UNITED STATES ENVIRONMENTAL PROTECTION AGENCY  
REGION III  
1650 Arch Street  
Philadelphia, Pennsylvania 19103-2029

The United States Environmental Protection Agency (EPA) has reviewed the Virginia Department of Environmental Quality's (DEQ's) request to amend the sediment Total Maximum Daily Load (TMDL) and waste load allocations (WLAs) for Dumps Creek, a tributary to the Clinch River. DEQ has identified five permitted point source facilities that were not included in the Dumps Creek sediment TMDL which was approved by EPA on June 6, 2004. DEQ is therefore requesting that the sediment TMDL and WLAs for Dumps Creek be modified to include allocations for these facilities.

RE: Total Maximum Daily Load modification for the wasteload allocation in the benthic TMDL for Dumps Creek, a tributary to the Clinch River.

This letter is to request approval of a modification to the wasteload allocation (WLA) table for the Total Maximum Daily Load (TMDL) for sediment developed for Dumps Creek in Russell County, Virginia. EPA Region III approved the sediment TMDL addressing a benthic impairment for Dumps Creek on June 6, 2004.

**Figure 4.2** Permitted point sources, operational during the modeled period.

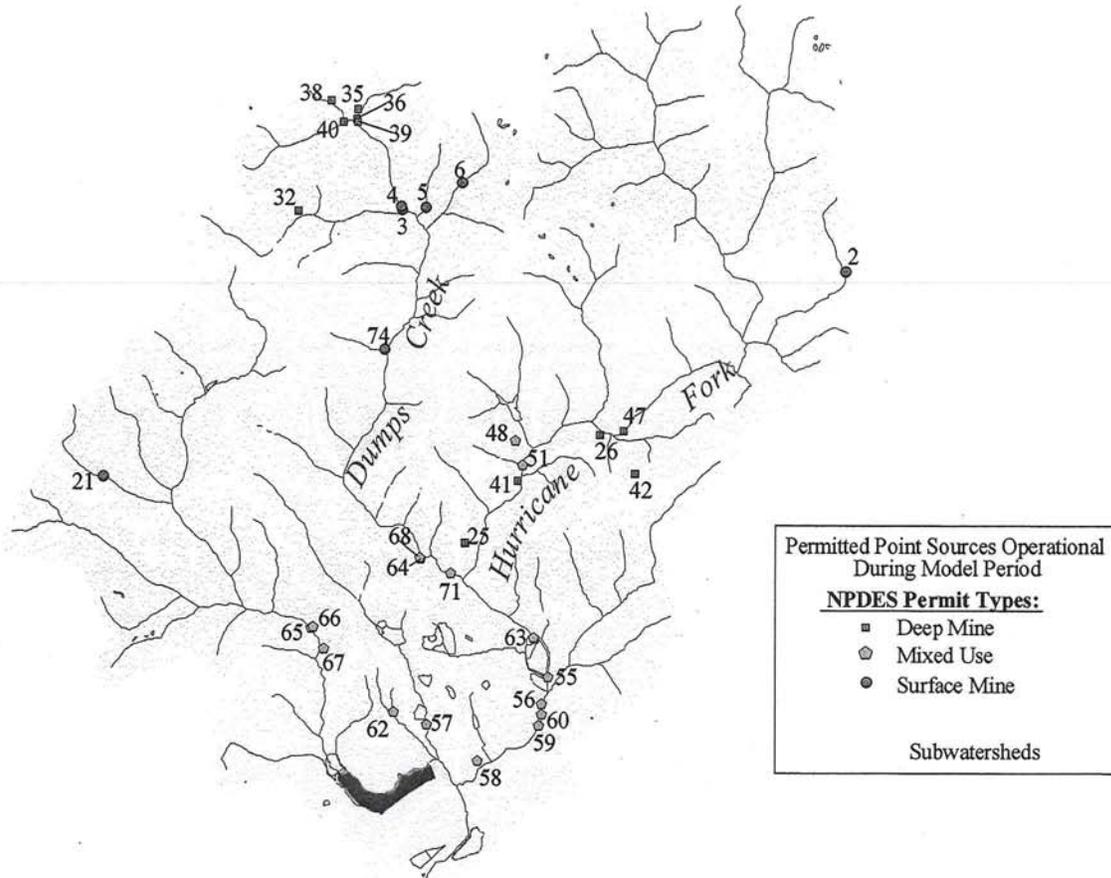
'There are 80 point sources permitted to discharge into Dumps Creek; 43 of these are mining permits known (observed) to produce flow to the watershed (Figure 4.2). The NPDES discharges are listed in Appendix C (Table C.1 and Table C.3).'

There were eighty point sources permitted to discharge in the watershed during the modeled period, of these, 43 are mining which are known (observed) to produce flow to the watershed (Figure 4.2). These NPDES discharges are listed in Appendix C (Table C.1 and Table C.3). Discharge volumes from control structures that collected surface runoff were calibrated using data collected in support of permit compliance. Through this calibration process, the hydraulic response of the structure was modeled. As such, minimum volumes of runoff in the ponds were required before discharge would occur. Evaporation from the ponds was dependent on surface area, which varied with depth. Pollutant loadings from the modeled ponds were dependent on the land use areas draining to the pond and the residence time in the pond. Discharges from control structures that collect and discharge water pumped from deep mines or comingled sources (i.e., both surface runoff and mine discharge) were modeled as a time series of flow and water quality constituent loads. These time series were developed based on monitored data and inserted into the appropriate subwatershed to represent the spatial distribution of the loadings along the stream channels.
